OFFICE OF ENVIRONMENTAL SUSTAINABILITY

INSPECTOR'S REPORT ON A WASTE LICENCE REVIEW, LICENCE REGISTER NUMBER W0217-02

Licensee: Killarney Waste Disposal Unlimited Company trading as KWD Recycling.
CRO number: 126626 (status: normal).
Location/address: Rural location approximately 4.5km northwest of Killarney town in the townland of Aughacurreen.
Application date: 16th July 2010.

Figure 1: Locations of Odour Receptors

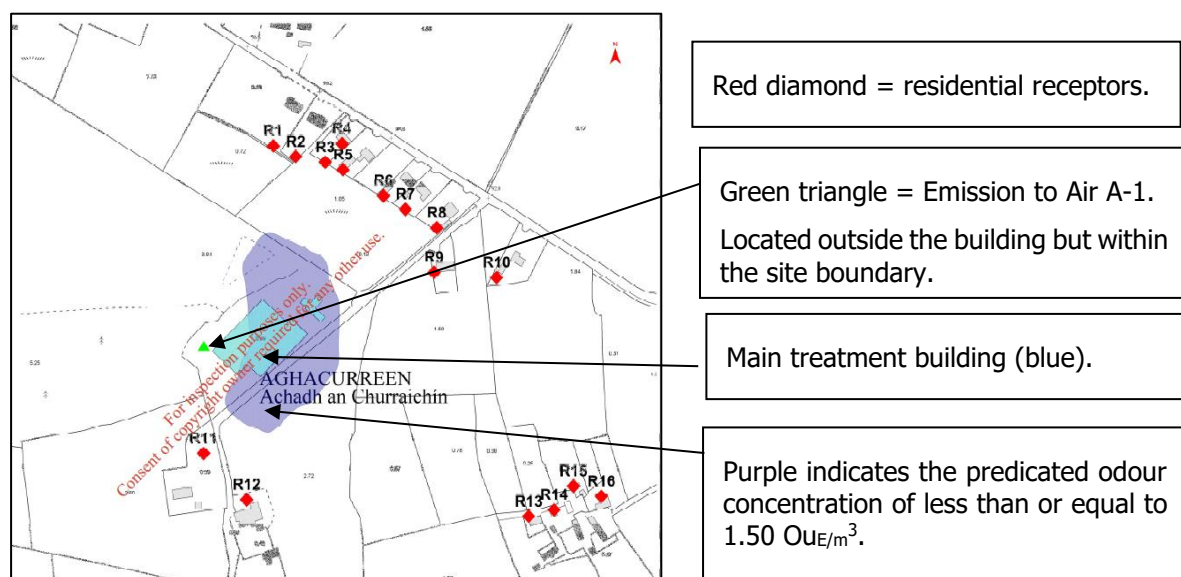
The emission of odorous air from the proposed emission to air (A-1) were modelled for odour impact at 16 receptors, numbered R1 – R16 shown in the figure below. The AERMOD prime model was used and the applicant followed the methodology outlined in the Agency Guidance Note AG4³.

The applicant proposed the use of the ambient standard of 3.0 O_{uE}/m^3 which, according to the EPA's Guidance Note AG4, relates to a facility which would be considered to have a medium level of relative odour offensiveness. The ambient standard of 1.5 O_{uE}/m^3 is more suitable to an activity involving the treatment of mixed municipal waste and municipal organic waste. The model predicted odour concentrations at each of the 16 receptors less than 1.5 O_{uE}/m^3 . Taking the above into consideration the emission limit value recommended in *Schedule B.1* is 1,000 O_{uE}/m^3 for emission point A-1.

Figure 2: Groundwater borehole locations and groundwater contour (June 2016).

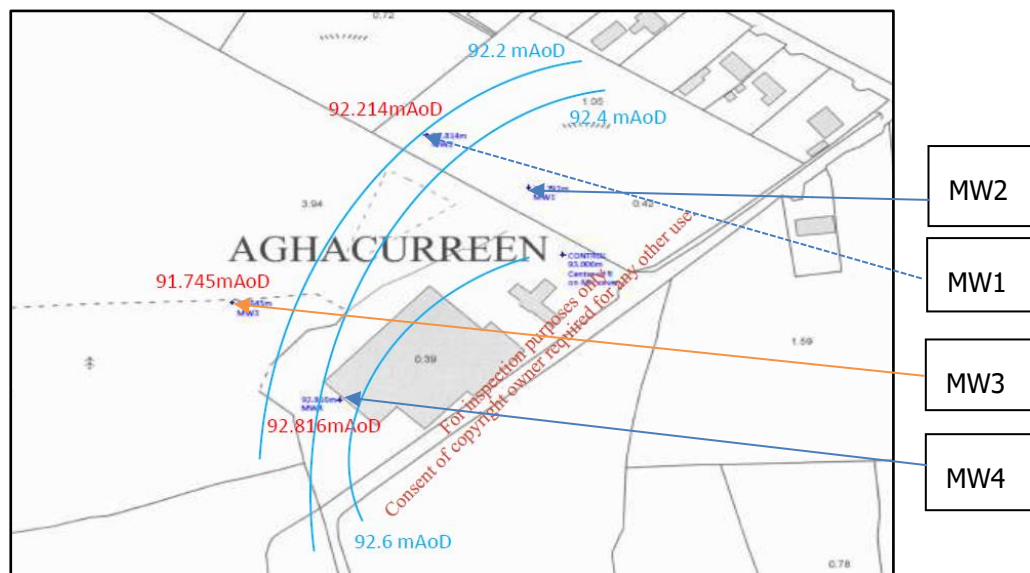
The OEE have concerns regarding the location of the above monitoring boreholes and whether they sufficiently represent up-gradient and downgradient locations in the Scartaglin groundwater body beneath the facility.

Figure 4: Noise monitoring locations NML1, NML2, NML3 and NML4.

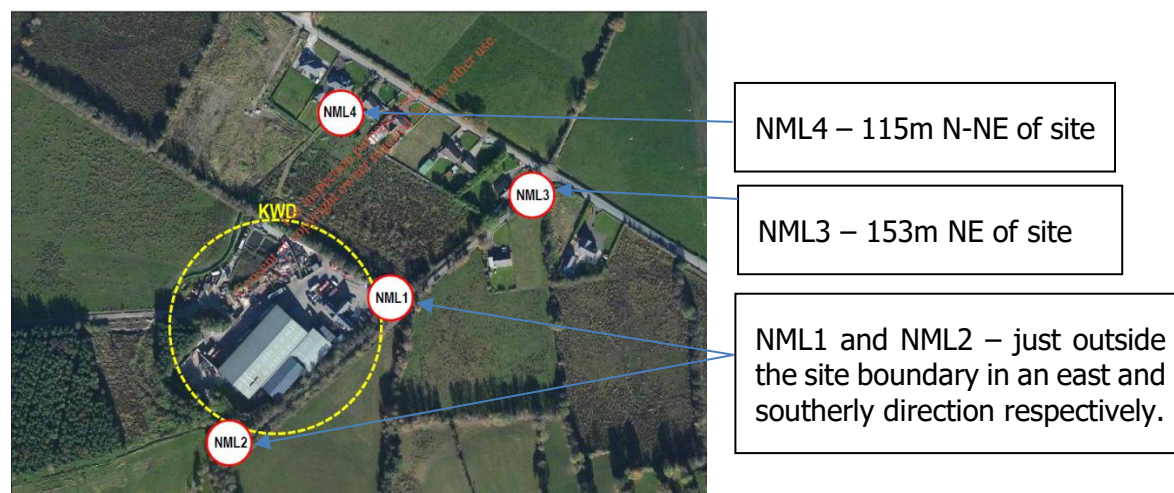
The noise survey completed in 2004 recommended that specific mitigation measures would be required if the facility was to operate outside the hours of 08:00 to 22:00 as the generator and site activity noise can exceed the night time ELV of 45dB(A) L_{Aeq} (15 minutes) on the eastern site perimeter. The recommended measures included:

- the noise surveys did not include night-time hours;
- the survey completed in 2017 took place while the facility was being operated; however, the plant or equipment in use and the activities taking place at the facility during the survey period was not identified.
- the site notice erected at the time the licence review application was made did not indicate the intention to increase the hours of operation at the facility.

- Condition 2.2.2.7 requires a preventative maintenance programme at the facility to maintain plant operating effectively.
- Condition 6.21 requires the licensee to carry out a noise survey as required by the Agency.
- Condition 1.8 sets out the hours of waste acceptance and operation of the facility.
- Standard noise conditions and limit values, which apply at the noise sensitive locations, have been included in the RD. In accordance with the EPA document *Guidance Note for Noise: Licence Applications, Surveys and Assessments in relation to Scheduled Activities (NG4) (2016)*, the day time limit has been changed from 55dB LAeq to 55dB LAr,T to allow for corrections for tonal noise, and an evening time emission limit value has been introduced.

Figure 8: Authorised sequence of yard drainage to ground (Condition 3.13.2, W0217-01).

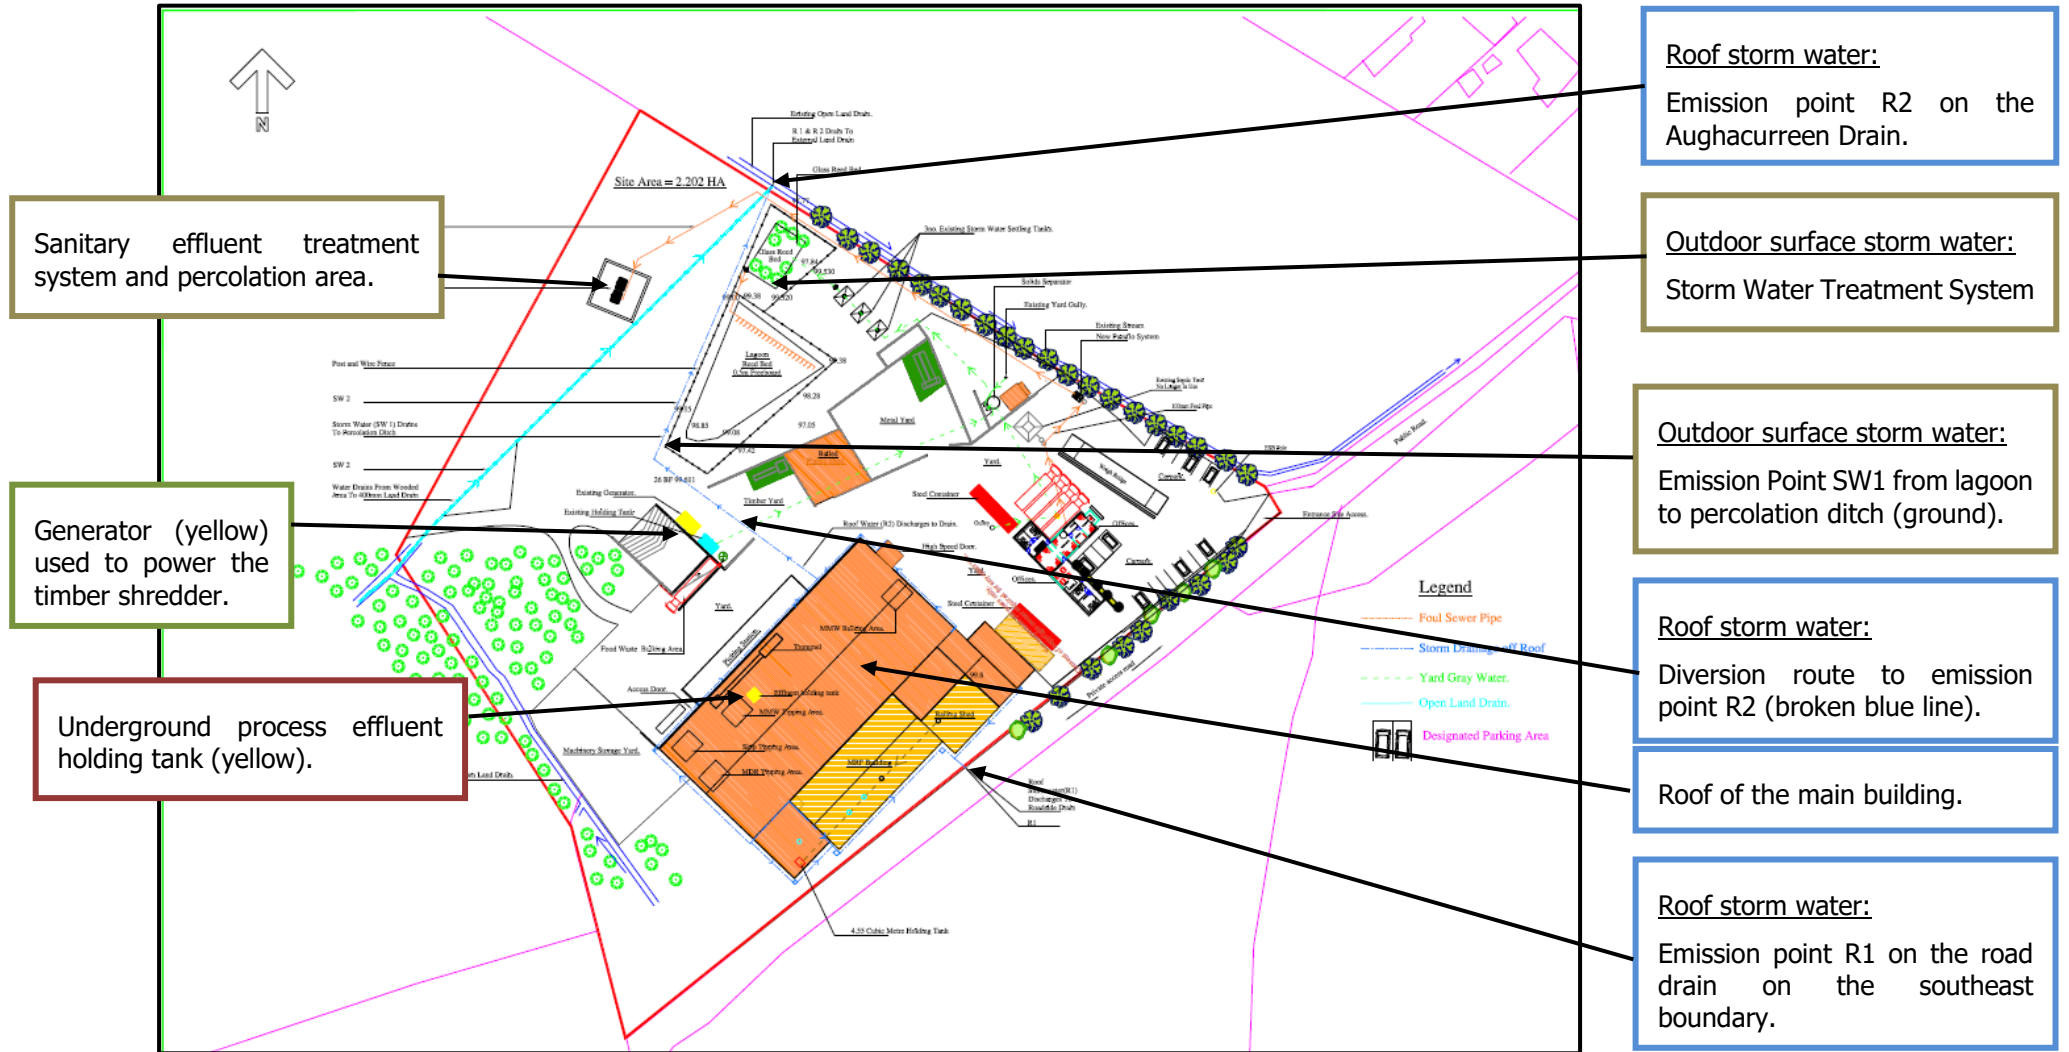
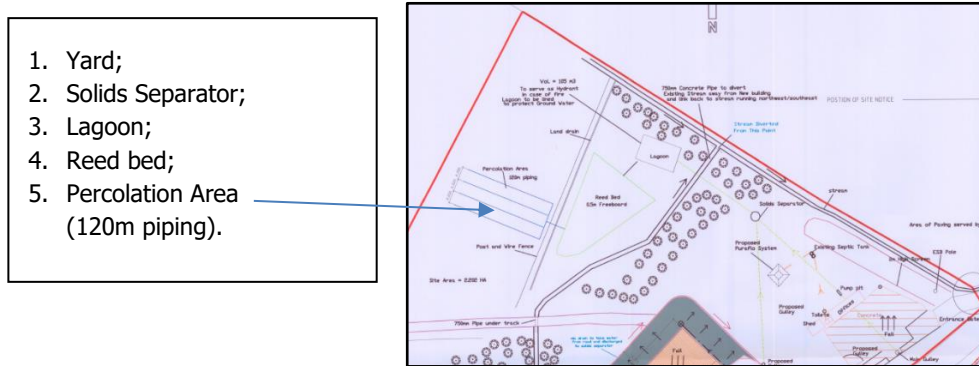
Condition 3.10 of the current licence requires the treatment of storm water from yard areas as described in Drawing Number, 02-034-J4-MCOS2F03; however, this is not reflected on-site as described in Table 10 below. The above drawing and a drawing of the current site drainage are shown in figure 8 and 9 of the Appendix.

- Condition 6.10 requires the integrity testing of all underground pipes;
- Condition 3.17 requires storm water run-off from yard areas to be treated via a silt trap and oil separator. Condition 6.15.5 requires this treated storm water to be directed to a percolation area as describe drawing number 02-034-J4-MCOS2F03;

Figure 9: Current sequence of yard drainage to ground.

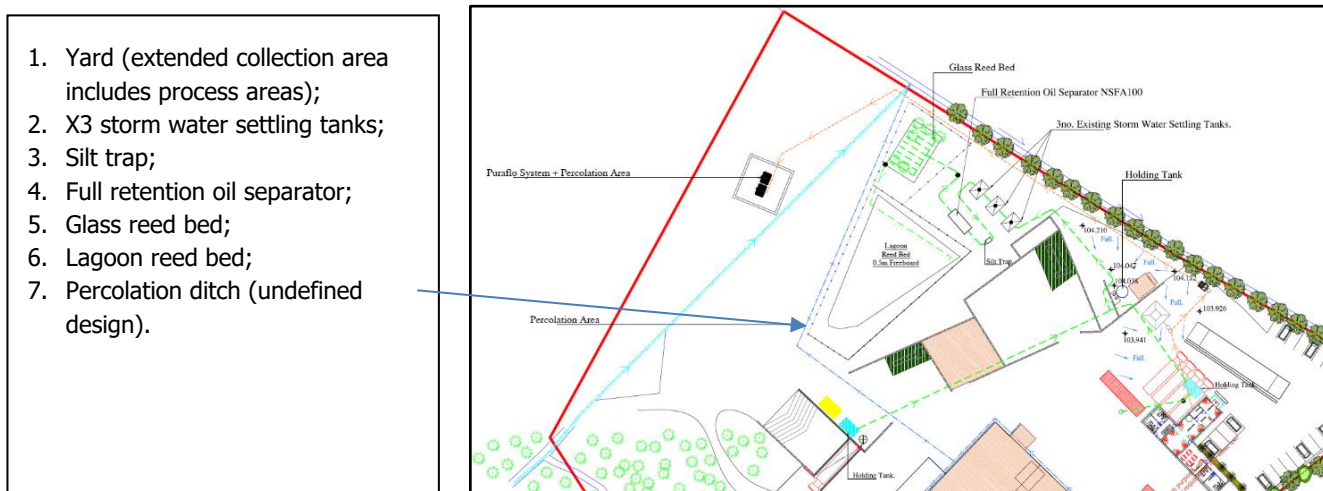
The current drainage and treatment system in place at the facility does not match the drawing above, as shown in Figure 7 below (Drawing Number 02).
